MICHIGAN DEPARTMENT OF ENVIRONMENTAL QUALITY

SUBJECT: Response to Question from March 17, 2009, North Bronson Industrial Area (NBIA)  
Meeting Regarding the Completion of the Groundwater Delineation Work

NORTH BRONSON  
INDUSTRIAL AREA SITE  
OPERABLE UNIT 1  
BRONSON, MICHIGAN

FIGURE 1

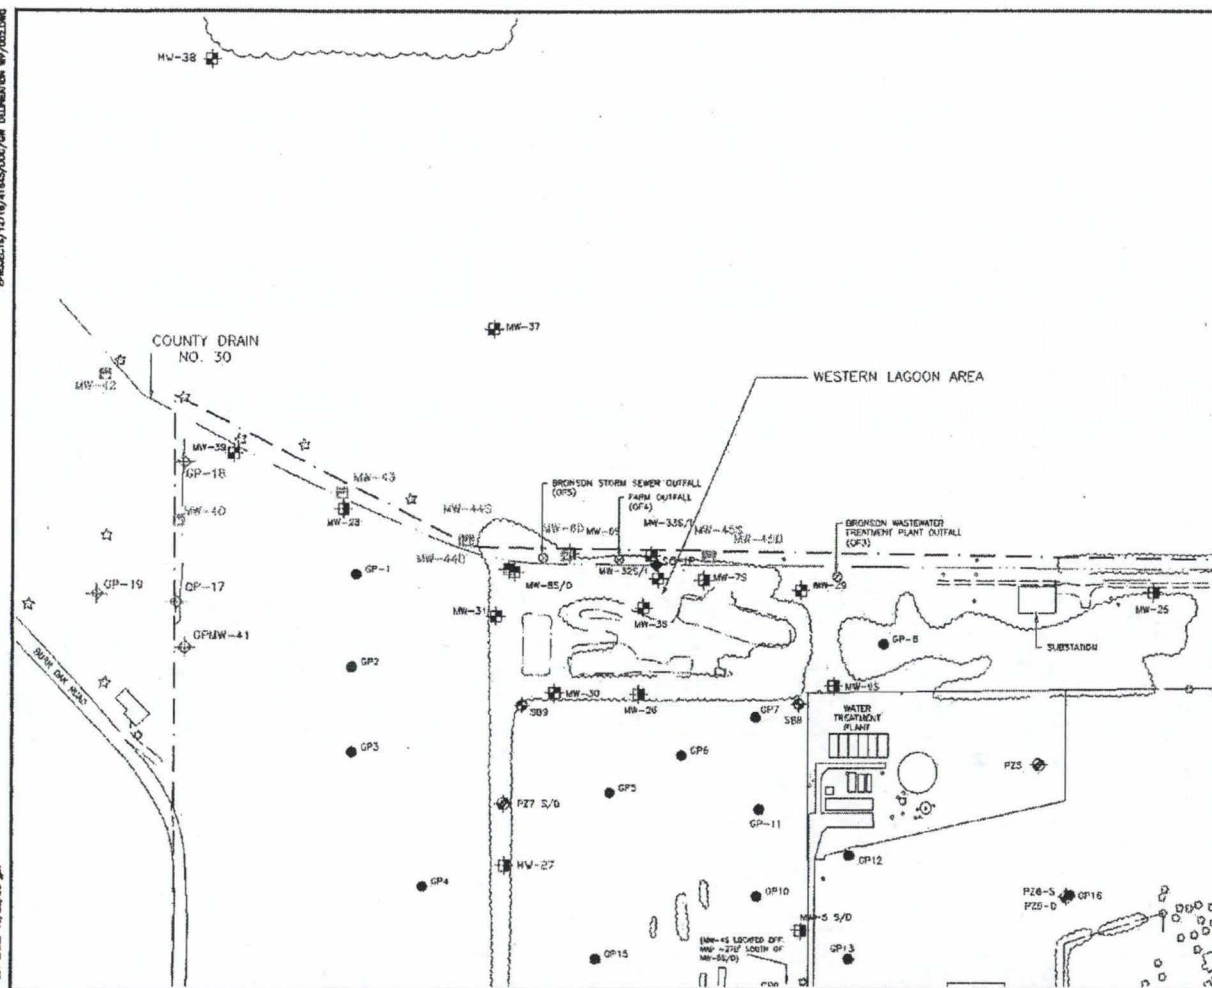
conditions. After my discussion with you yesterday, I still stand by this course of action. Attached is a site map with the Geoprobe VAS borings and new monitoring well locations, along with my choices for further plume delineation.

It is not possible to determine the plume boundaries west of the WLA with just two monitoring wells, especially when one of them is simply placed across CD #30 from another existing monitoring well. Incidentally, a boring location across from MW-42 was discussed during the call in September 2008. Delineation by installing monitoring wells alone is problematic by itself, and is rarely appropriate for performing delineation work. It is best to gather sufficient information using reconnaissance methods to decide the optimum locations for permanent monitoring well locations.

There are two main areas to focus the delineation work: to the west of GP-17, and along the north side of CD #30 to determine the plume boundaries as well as groundwater flow patterns. See the attached map for these locations (stars on the map). If the locations across from MW-39 and MW-42 have contaminant concentrations above regulatory standards, then the VAS boring located between them should be installed.
